Description	Grimsby B Reserve Site: Addendum to report reference PJ3979/16440/V1. <i>Environmental Noise Assessment to inform potential impacts of proposals</i>
Date	28 July 2022
Issued by	Peter Jackson MSc MIOA. Principal Consultant
Issued to	RWE Generation UK plc
Ref No	PJ4147/16440

This addendum report provides a review of any potential change to the noise impact of the Grimsby B development, due to the above scheme changes.

Figure 1: Plan of Grimsby A & B Sites showing as-built A-Site and proposed B-Site layout (red line boundary)

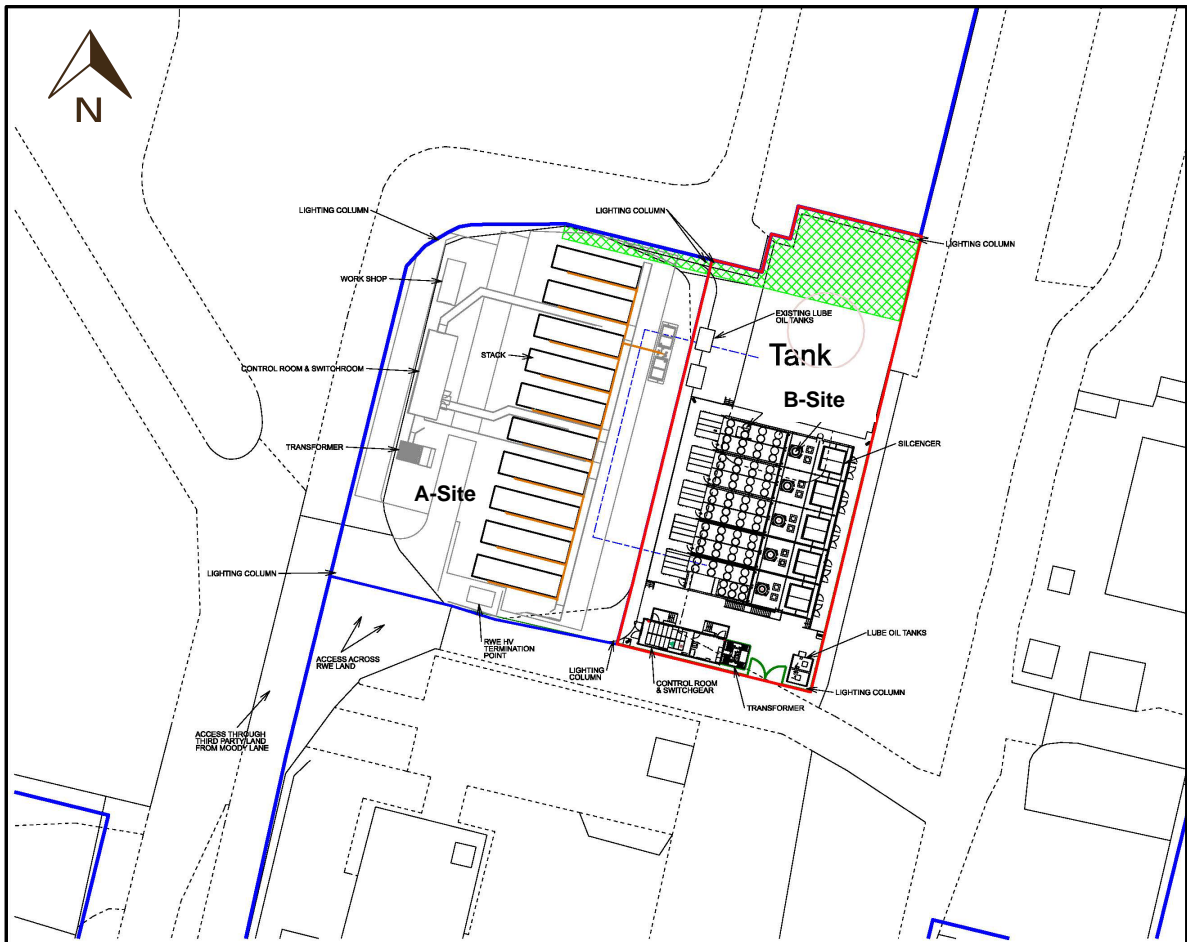
- Change to the type of Gas-Engine type, together with changes to engine enclosure design and position of external plant on and around the enclosure;
- Change to the B-site layout, consistent with a reduction in the number of gas engines and to accommodate the larger building enclosure design.

The revised site layout covering Grimsby A & B sites is shown in Figure 1.

The as-built 10 x gas engine units, comprising the A-site are shown located on the west half of the site, with the 5 x gas engine units comprising the B-site located on the eastern half of the site, as delineated by the red line boundary.

Figure 2: Detail of the Grimsby B site gas-engines, showing elevations and position of external plant items.

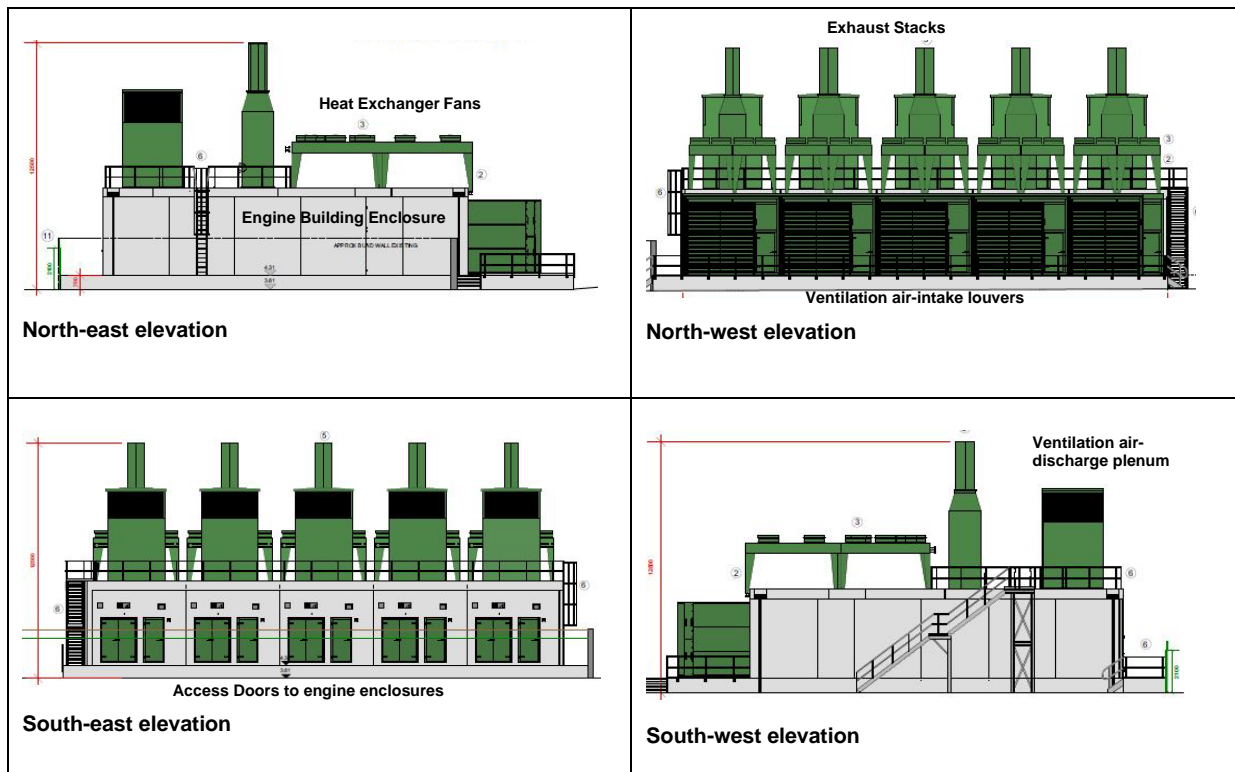
Detail of the Grimsby B site gas-engines, showing elevations and position of ventilation openings, exhaust stack and cooling heat exchangers is shown on the drawings included in Figure 2.

The drawings show the 5 x engine cells positioned side by side. The air-intake / ventilation opening to each building enclosure is shown as the louvred opening in the north-west elevation. The air-discharge opening is shown as the louvred openings across each side of the plenum located on the roof of the enclosure.

The exhaust stack extends from the back of the engine, through the roof of the enclosure, discharging 12.5m above the enclosure building.

The heat exchanger cooling fans are located on an open frame fixed to the top of the enclosure roof.
